## **THE TOWN OF SALTIRE BAY FRONT DISTRICT** **SUBDIVISION**

APPLICATION NUMBER 9 DATE March 4, 2010  
APPLICANT The Town of Salt Aire Bay Front District Subdivision  
REQUEST Subdivision

# DETAIL SITE PLAN

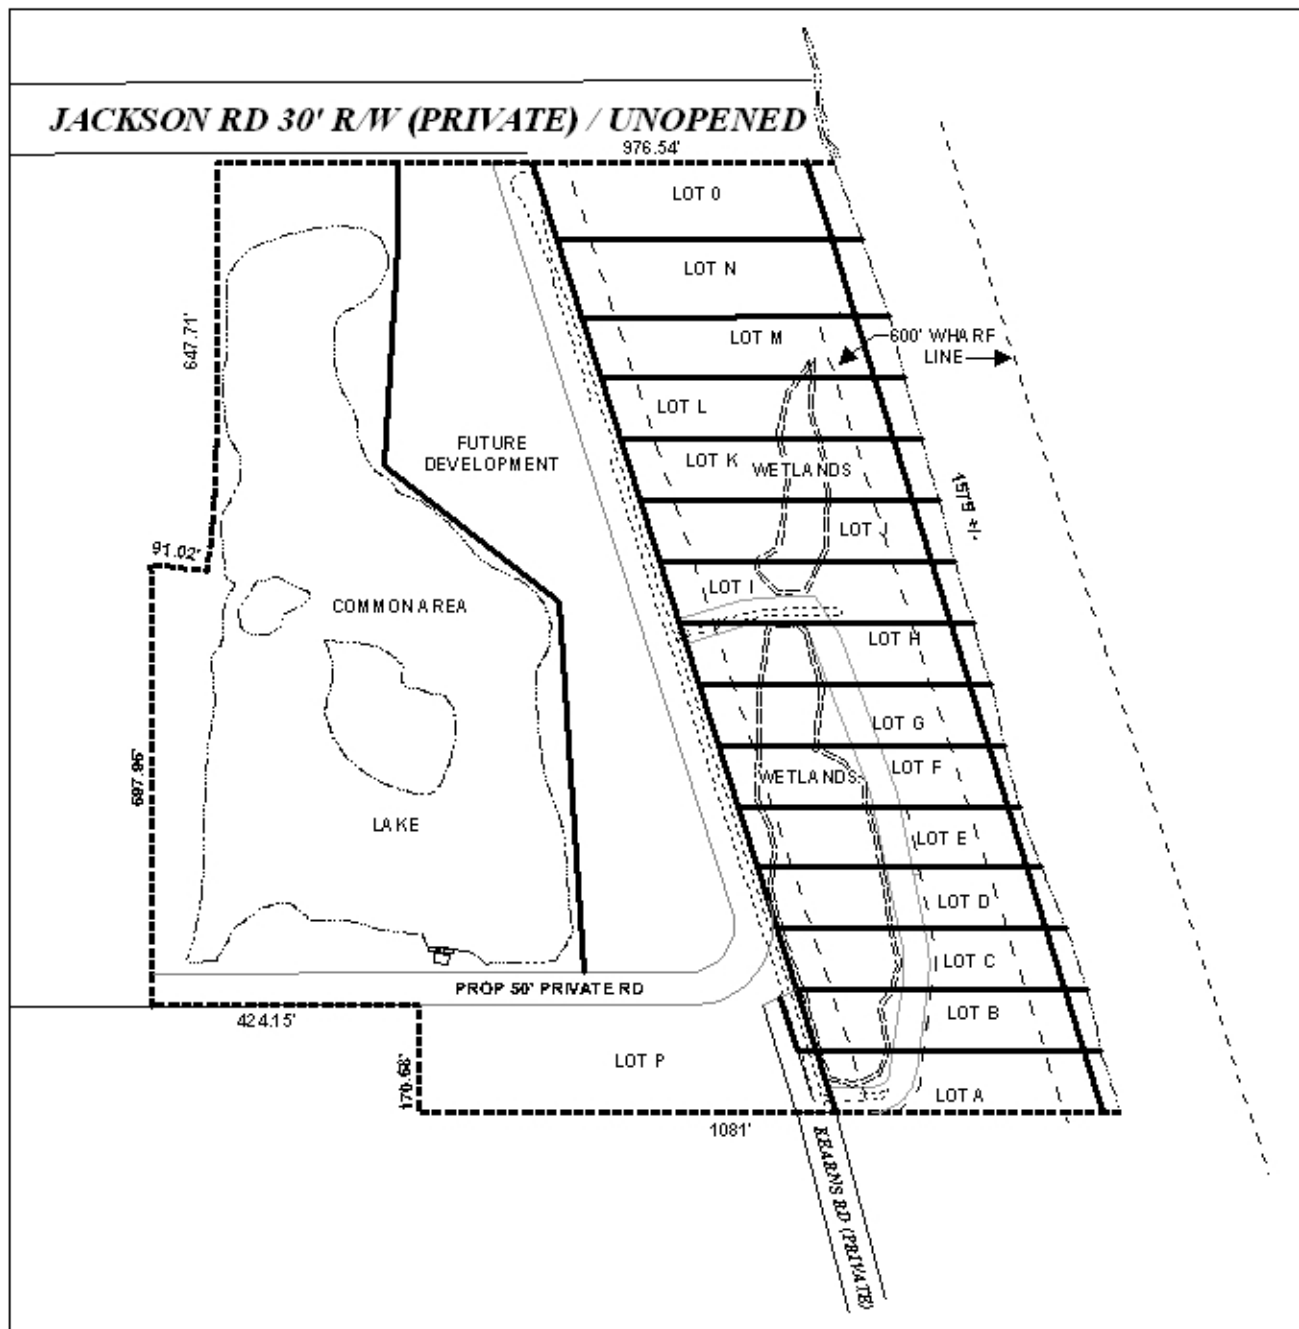
60' right-of-way, but is unpaved. The plat does not indicate a turn-around at its North terminus; therefore, the plat should be revised to indicate a 120'-diameter cul-de-sac at the North terminus in accordance with the requirement of Section V.B.14. of the Subdivision Regulations. The applicant is requesting a waiver of the 2' wing requirement of Section VIII.E.2.c on each side of Bay Front Drive in favor of parallel swale ditches in accordance with County standards. As the wings are a requirement of the City's Subdivision Regulations pertaining to private streets, this requirement should be adhered to along all proposed streets within the subdivision. As all roads are proposed to be private, a note would be required on the Final Plat stating that the maintenance of the roads is the responsibility of the property owners and not Mobile County.

The plat indicates the original 50' minimum building setback line along the East side of Bay Front Drive, but no minimum setback is indicated along the West side of Bay Front Drive or along either side of Bridge Water Drive; therefore, the plat should be revised to indicate a 25' minimum building setback line where not shown. As a means of access management, a note should be required on the final plat stating that each lot along Bay Front Drive is limited to one curb cut, and Lot P is limited to two curb cuts to Bridge Water Drive, with the size, location and design of all curb cuts to be approved by County Engineering and conform to AASHTO standards. A note should also be required on the Final Plat stating that there shall be no access to Kearns Road to the South of the subdivision.

Although not indicated on the plat, all lots scale to meet minimum lot area standards. All lots should be labeled on the Final Plat with their sizes in square feet and acres, or a table should be furnished on the Final Plat providing the same information. All lot dimensions are not shown on the plat; therefore, the plat should be revised to indicate all lot dimensions on the Final Plat.

Three additional buildable lots are proposed beyond the originally platted 13 buildable lots of Western Shoreline Estates Subdivision, Unit Two. All three are along the East side of Bay Front Drive. As a result, all lots along the East side of Bay Front Drive would exceed the depth-to-width ratio of Section V.D.3. of the Subdivision Regulations. However, such ratios are typical of waterfront properties, and several of the lots contain unusable wetlands which, when excluded, would actually bring the ratios into compliance. Therefore, a waiver of Section V.D.3. would be in order. As a result of the closing of the Southern portion of Kearns Road within the subdivision and the realignment of Bay Front Drive to connect to Bridge Water Drive, Lots A and B would ordinarily not have any road frontage. However, short flag lot "stems" are proposed extending from the main lots to provide each with approximately 30' of frontage along Bay Front Drive: unusual lot shapes adjacent to Mobile Bay and its tributaries are not uncommon. A waiver of Section V.D.1. of the Subdivision Regulations may be in order to provide such.

The area along the West side of Bay Front Drive is labeled as Future Development; however, aerial photographs of the site indicate established amenities such as a tennis court and gazebo within this area near the South end of the lake. If such are to remain and be for common property owners' use, the boundary for the Future Development should be revised to exclude these amenities and include them within the Common Area. Also, a large area immediately to the West of the lake is labeled Not Included. As this area is included in the original recording of Western Shoreline Estates Subdivision, Unit Two, as a Common Area, it should be included in

this subdivision, either as a Common Area or as Future Development. A note would be required on the Final Plat stating that the maintenance of all common areas is the responsibility of the property owners and not Mobile County.

- 1) revision of the plat to indicate a 120'-diameter cul-de-sac at the North terminus of Bay Front Drive;
- 2) construction of the private streets in accordance with Section VIII.E.2.c of the Subdivision Regulations;

- 4) revision of the plat to indicate a 25' minimum building setback line along all street frontages unless greater is indicated, including within future development and common areas;

- 5) placement of a note on the Final Plat stating that each lot along Bay Front Drive is limited to one curb cut, and Lot P is limited to two curb cuts to Bridge Water Drive, with the size, location and design of all curb cuts to be approved by County Engineering and conform to AASHTO standards;

- 6) placement of a note on the Final Plat stating that there shall be no access to Kearns Road to the South of the subdivision;
- 7) labeling of all lots with their sizes in square feet and acres, or the furnishing of a table on the Final Plat providing the same information;

- 8) revision of the plat to indicate all lot dimensions;
- 9) revision of the plat to remove the recreational amenities near the Southeast portion of the lake from the Future Development area and include them in the Common Area if such amenities are to be for common property owners' use;

- 10) inclusion of the area to the West of the lake labeled as Not Included to be either a Common Area or Future Development;
- 11) placement of a note on the Final Plat stating that the maintenance of all common areas is the responsibility of the property owners and not Mobile County;
